H4AA30-C2

History

Author: ZhiYong Song Version: V1.1

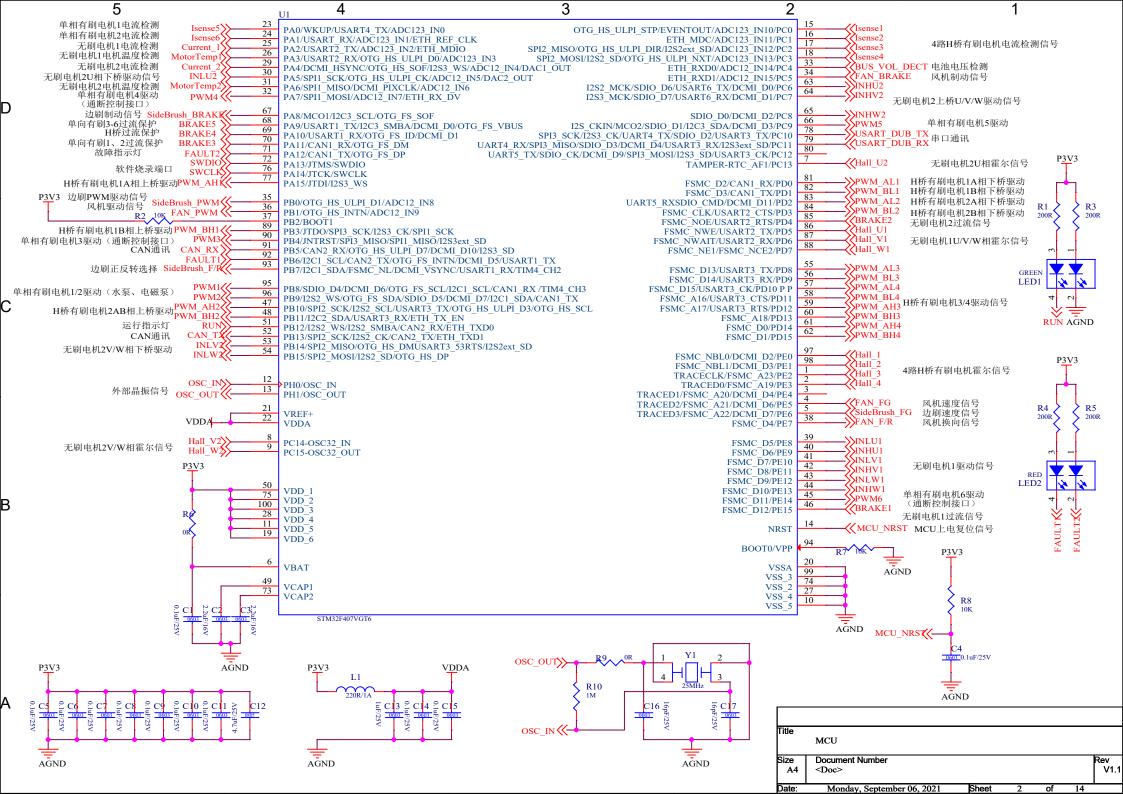
为了增加LED亮度,将限流电阻R1、R3、R4、R5由"1k/0603"变更为"200R/0805"

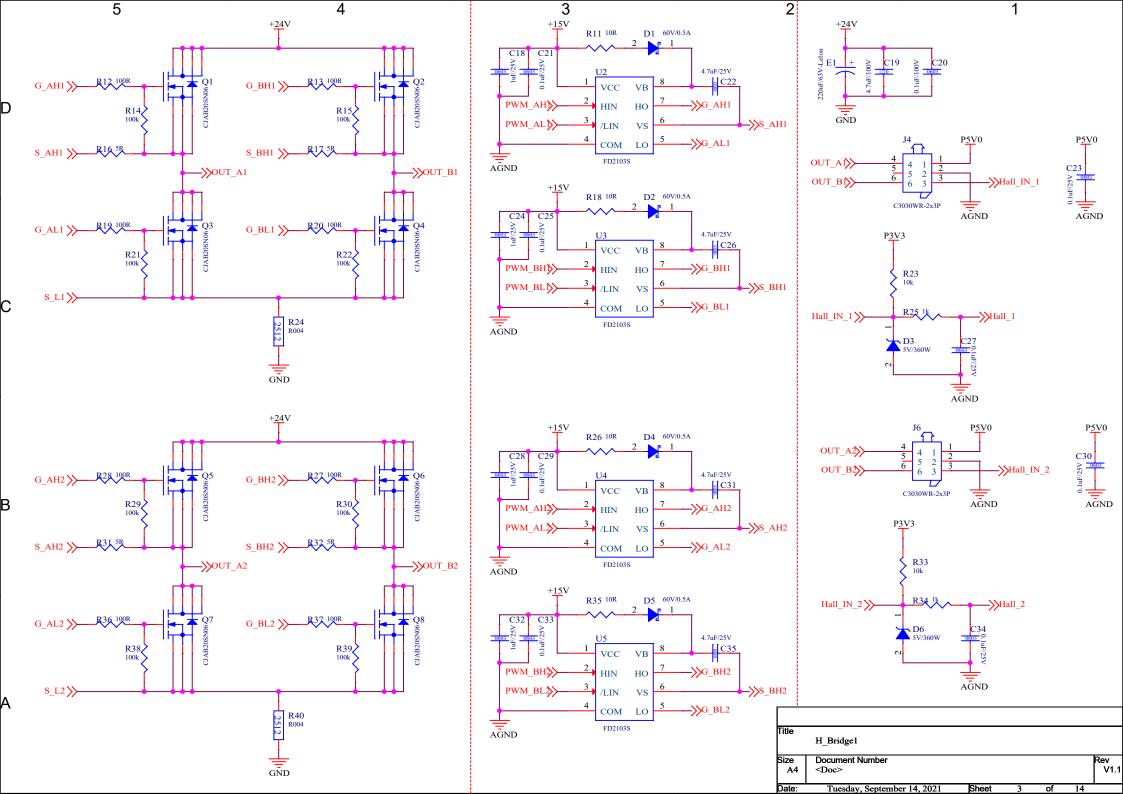
15V、5VBUCK电源输出电感L3、L4"22uH/0.52A"(SWPA3015S220MT)变更为"22uH/1.1A"(SWPA5020S220MT)

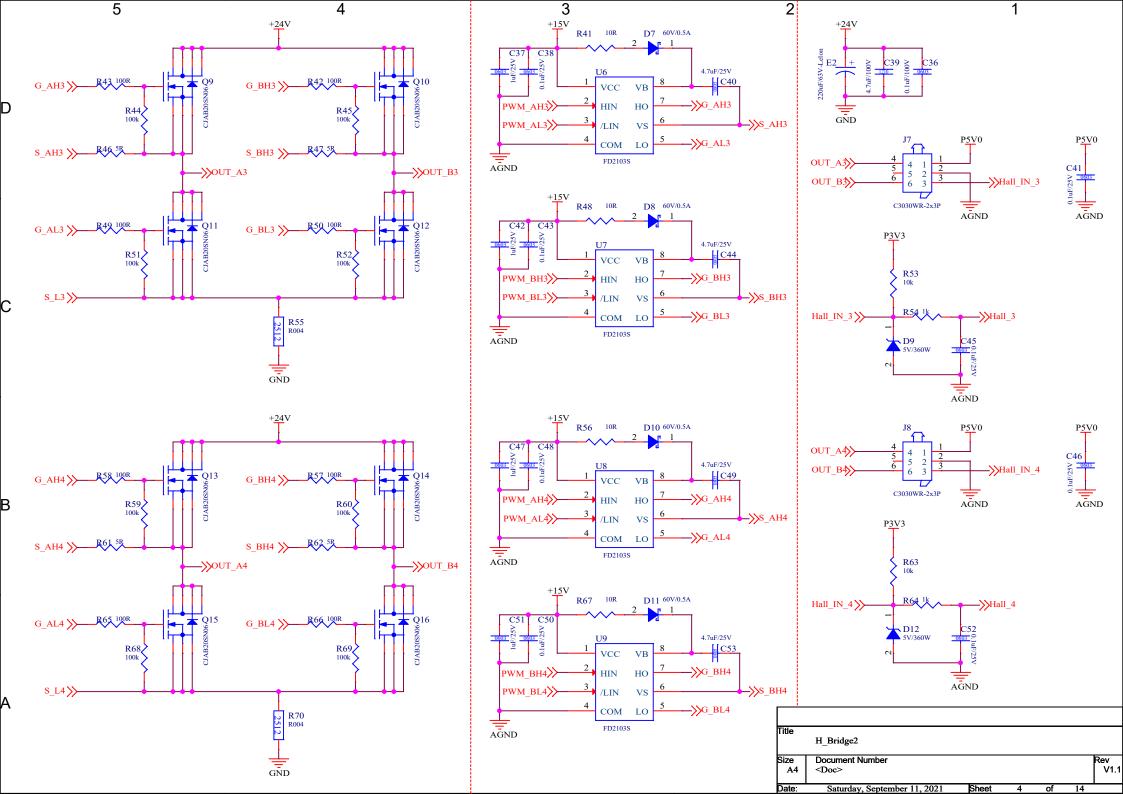
H桥有刷驱动电流采样电阻R24、R40、R55、R70由"10mΩ/1206/1W/1%"变更为"4mΩ/2512/3W/1%"

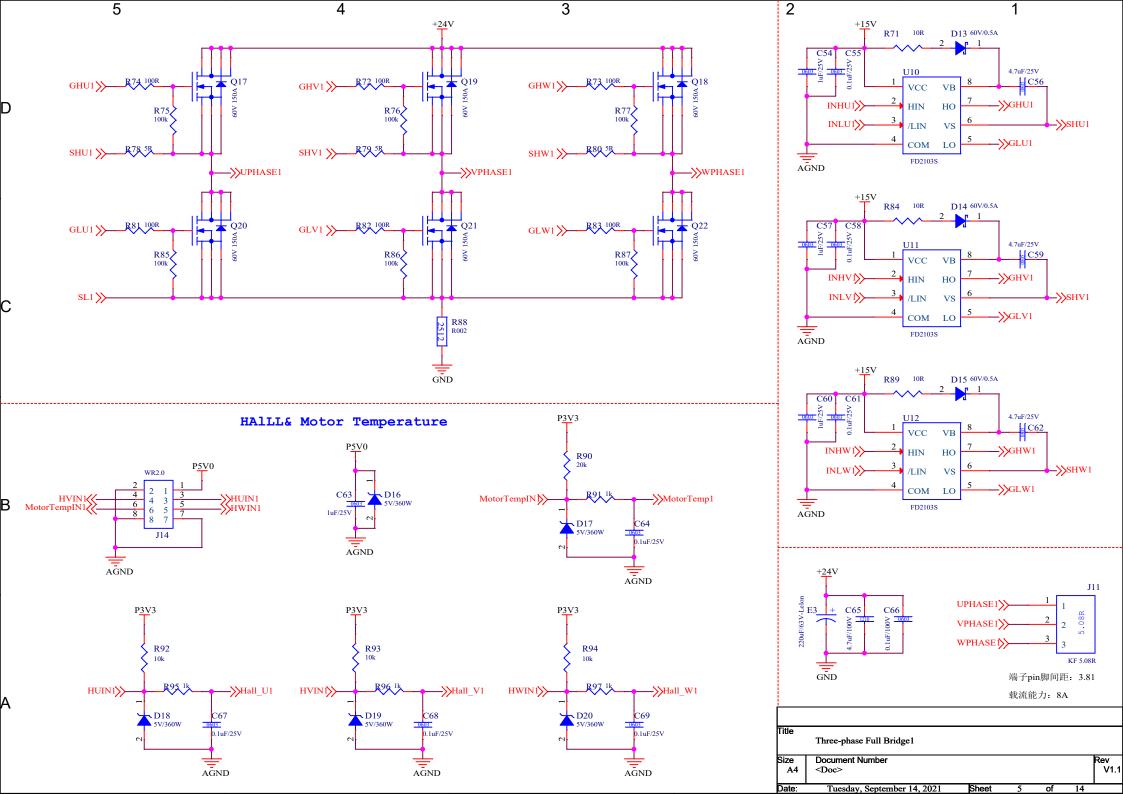
无刷电机霍尔反馈信号滤波电容C67、C68、C69、C83、C84、C85由"10nF/25V/0603"变更为"0.1uF/25V/0603"

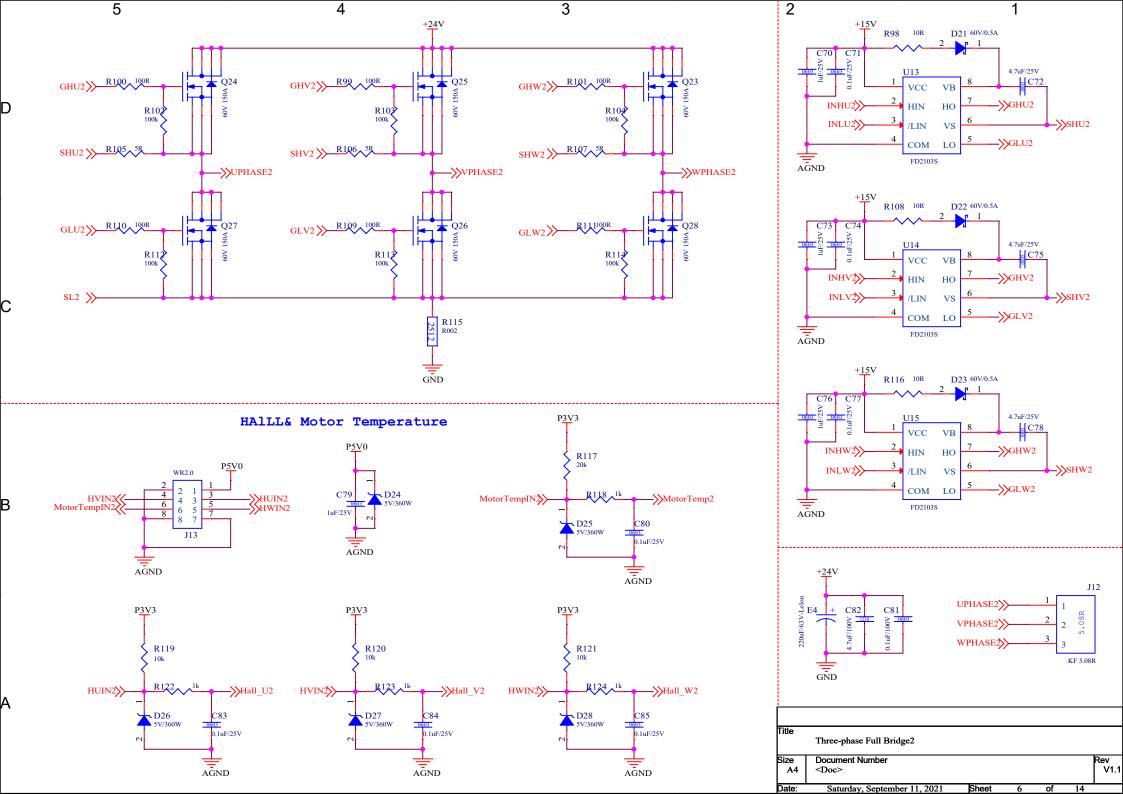
输入滤波电解电容E1、E2、E3、E4、E5、E6"100uF/63V", 变更为E1、E2、E3、E4、E5"220uF/63V", 删掉E6

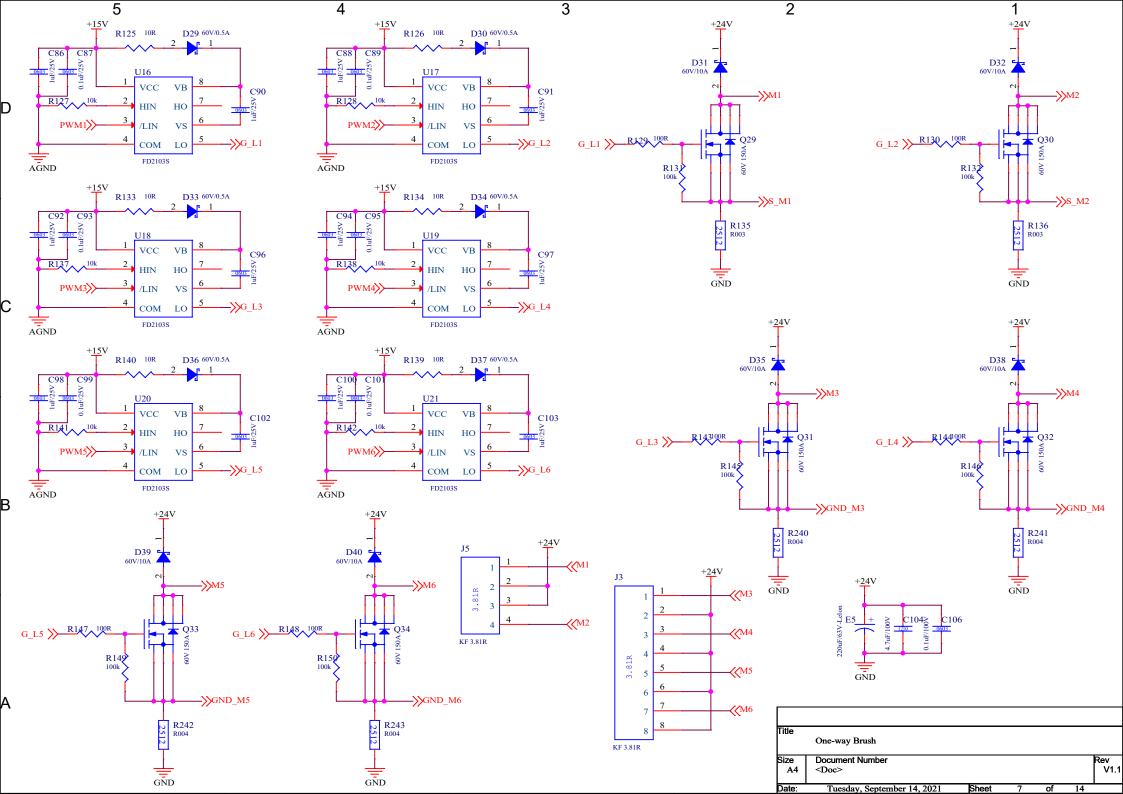
风机PWM信号FAN PWM与单向有刷6驱动信号PWM6互换网络;边刷PWM信号SideBrush PWM与单向有刷5驱动信号PWM5互换网络
